4/23/03	Revised 6'x4' Culvert Extension Per Change Order
DATE	REVISION
STATE OF HAWAII DEPARTMENT OF TRANSPORTATION HIGHWAYS DIVISION DRAINAGE PLAN - 1 KAMEHAMEHA HIGHWAY RESURFACING Waiahole Valley Road to Crouching Lion Inn Federal Aid Project No. NH-083-1(43)	
Scale: 1" = 10'	Date: August 1, 2000
SHEET No. C-27 OF 65 SHEETS

KAMEHAMEHA HIGHWAY RESURFACING
Waiahole Valley Road to Crouching Lion Inn
Federal Aid Project No. NH-083-1(43)

FED. ROAD DIST. NO.	STATE	FED. AID PROJ. NO.	FISCAL YEAR	SHEET NO.	TOTAL SHEETS
HAWAII	HAW.	NH-083-1(43)	2001	C.O.34S-1	121

Scale: 1" = 100'

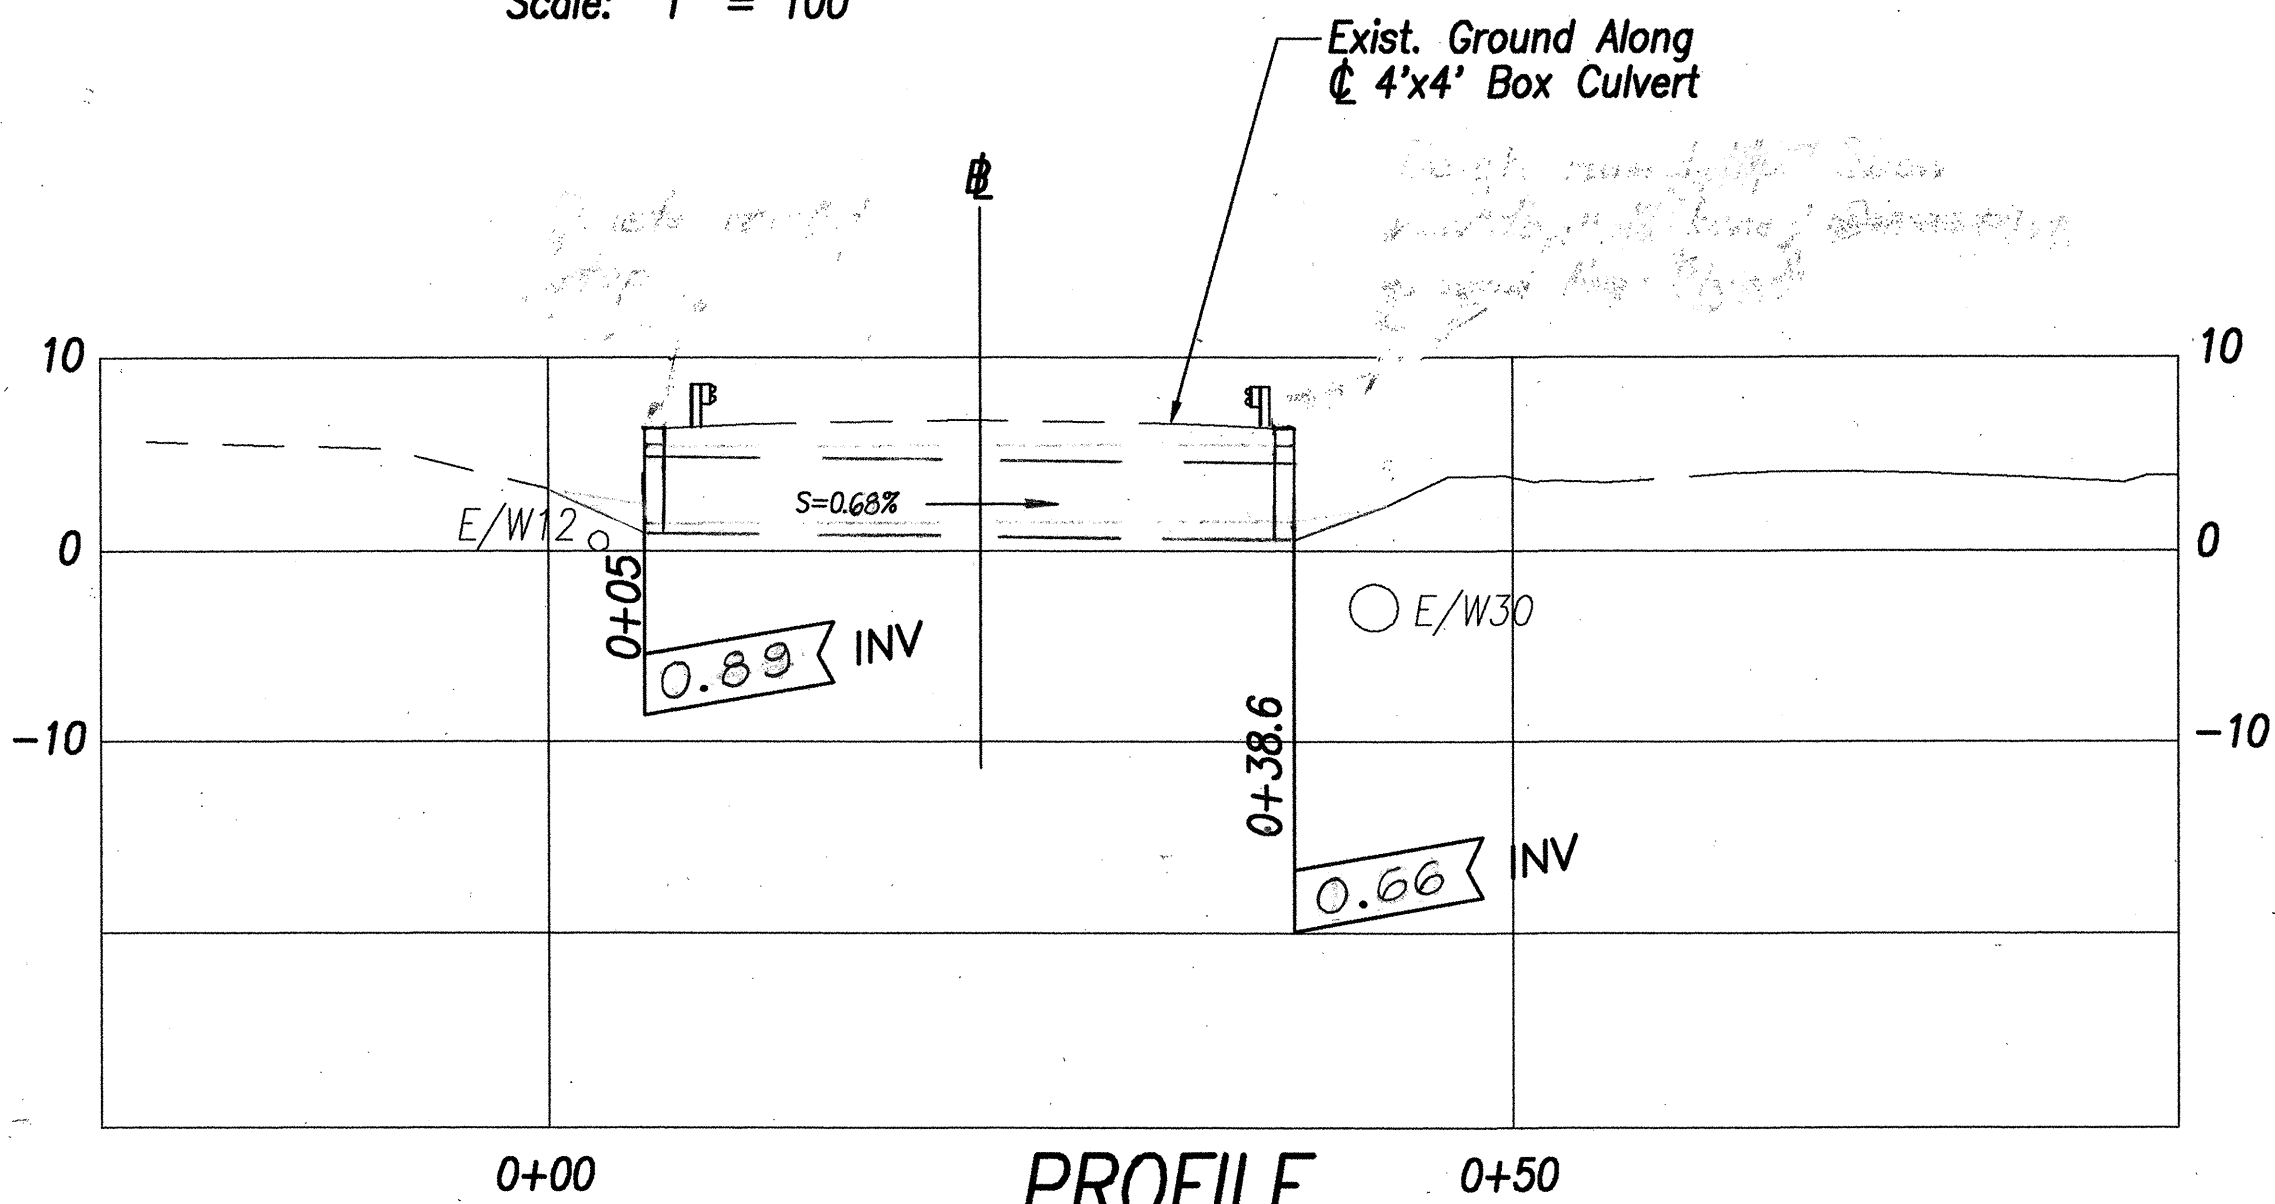
2/4/02	Revised Sta. 555+05 Culvert Inverts Per Addendum No. 2
DATE	REVISION

STATE OF HAWAII
DEPARTMENT OF TRANSPORTATION
HIGHWAYS DIVISION
DRAINAGE PLAN

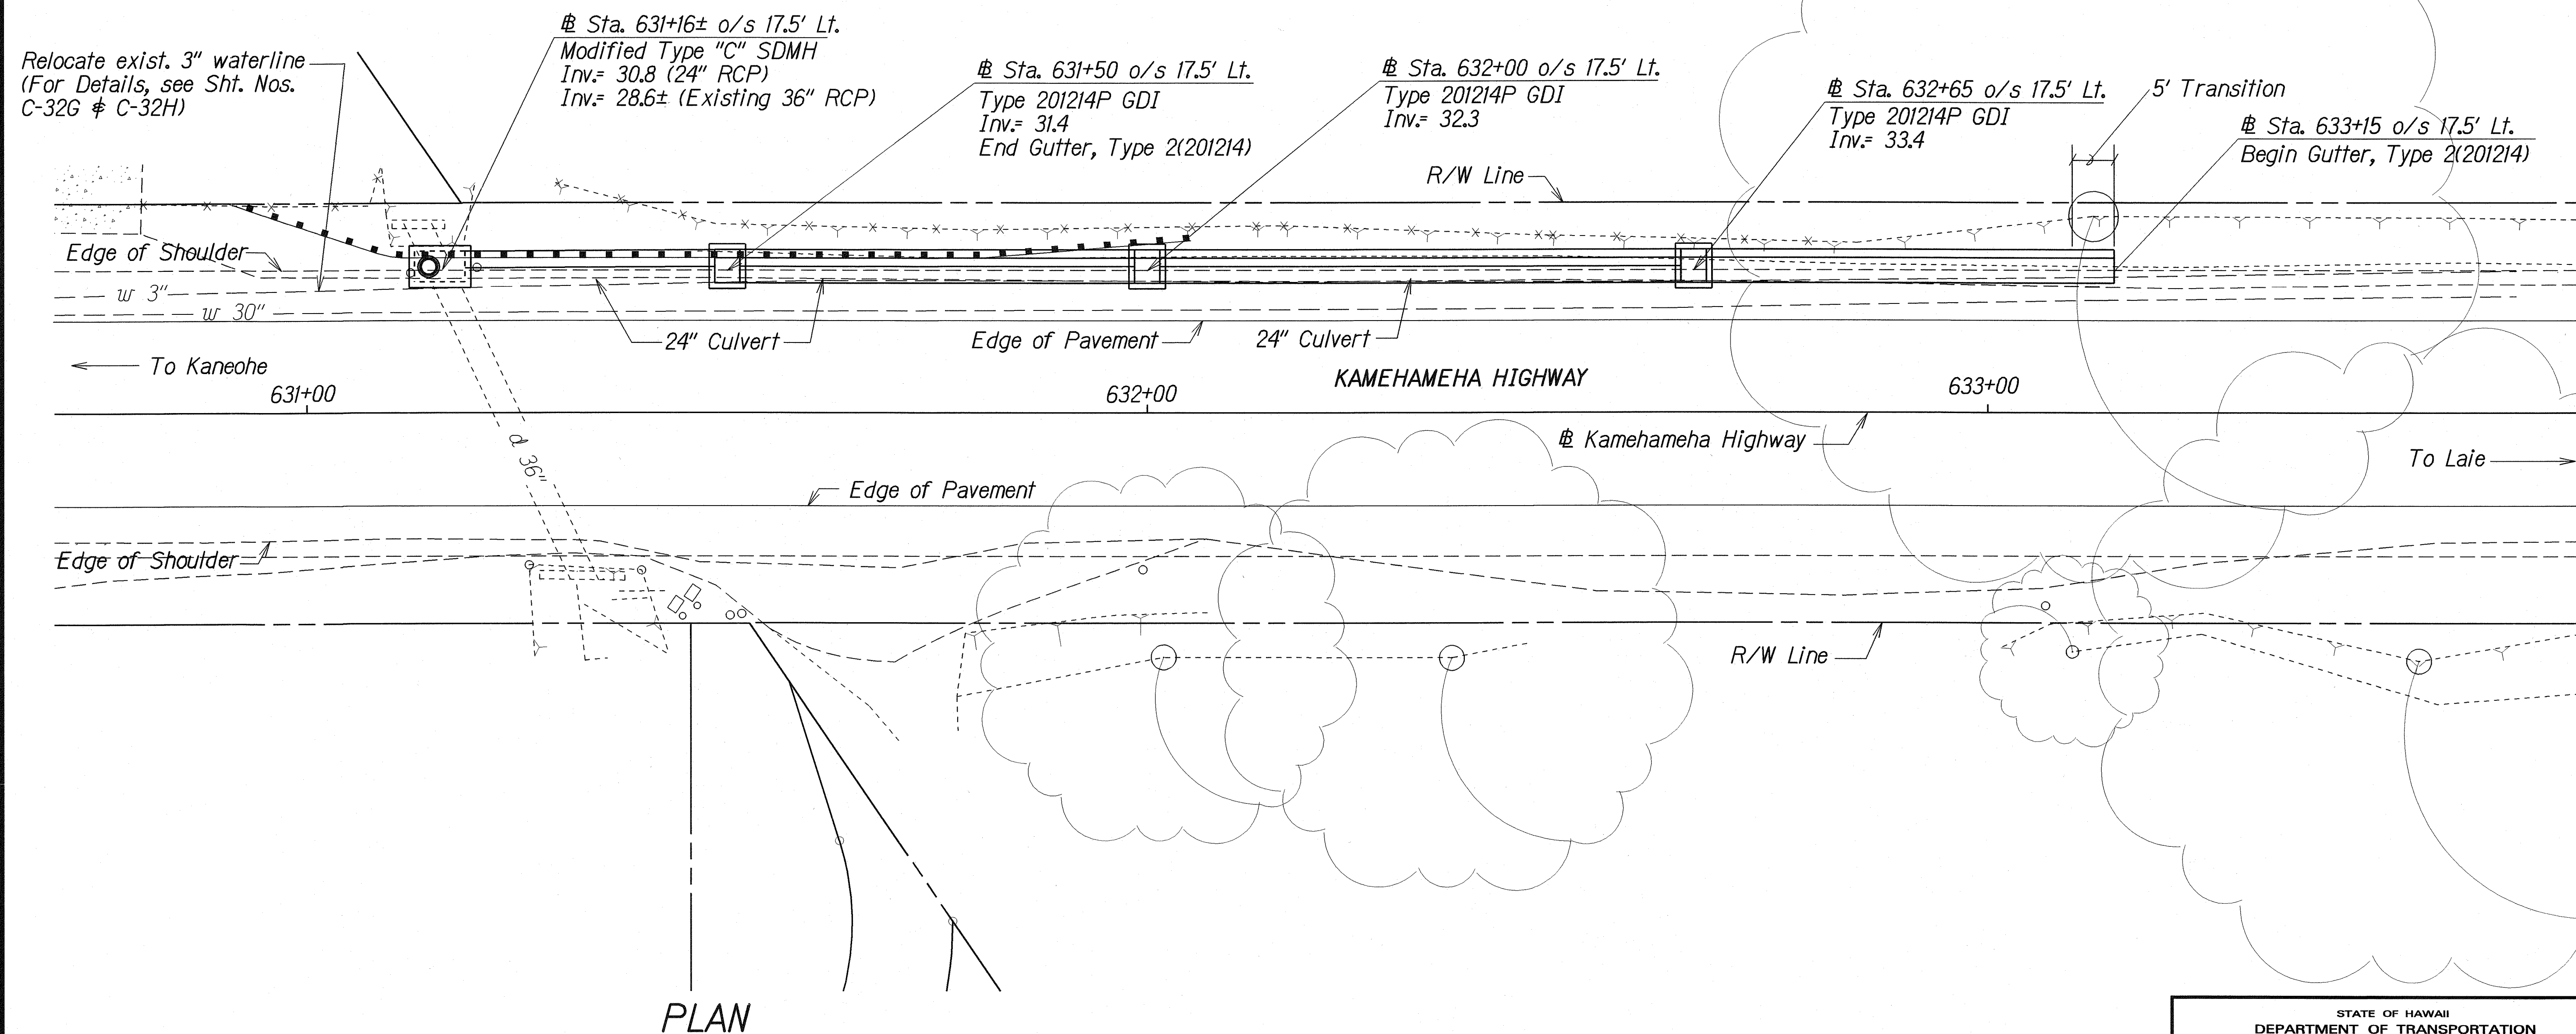
9/3/02	Add drainage plan sheet.
DATE	REVISION

☺ PROFILE ALONG 24" CULVERT AT # STA. 631+16± o/s 17.5' LT. TO # STA. 632+65 o/s 17.5' LT.

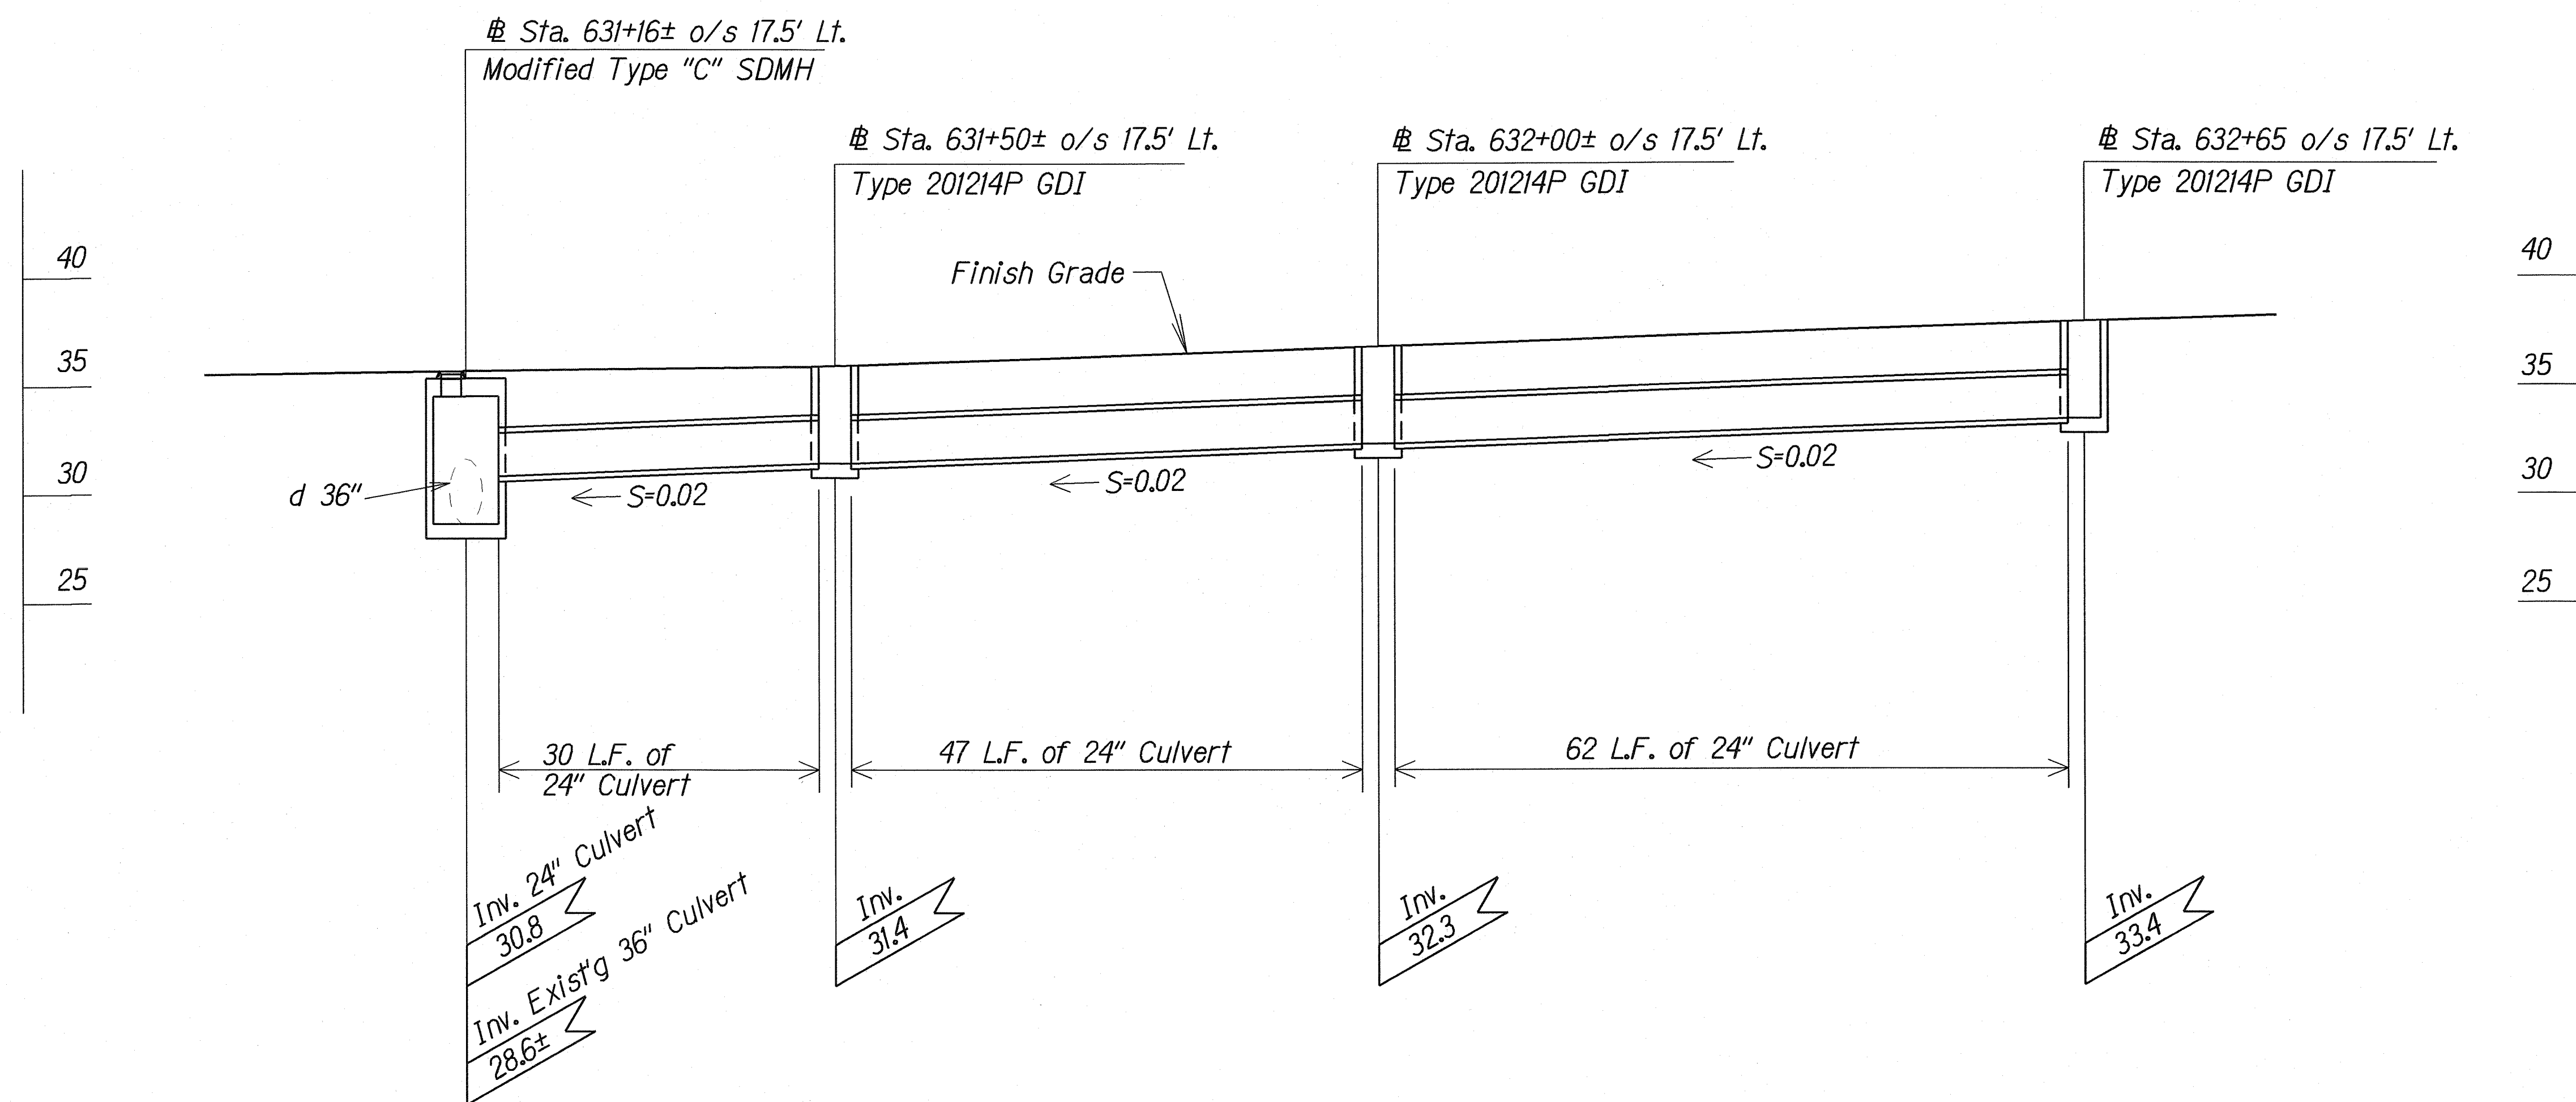
9/3/02	Add drainage profile sheet.
DATE	REVISION
STATE OF HAWAII DEPARTMENT OF TRANSPORTATION HIGHWAYS DIVISION DRAINAGE PROFILE KAMEHAMEHA HIGHWAY RESURFACING Waialeale Valley Road to Crouching Lion Inn Federal Aid Project No. NH-083-1(43) Scale: 1" = 10' Date: Apr, 2002 SHEET No.C-32B OF 74 SHEETS
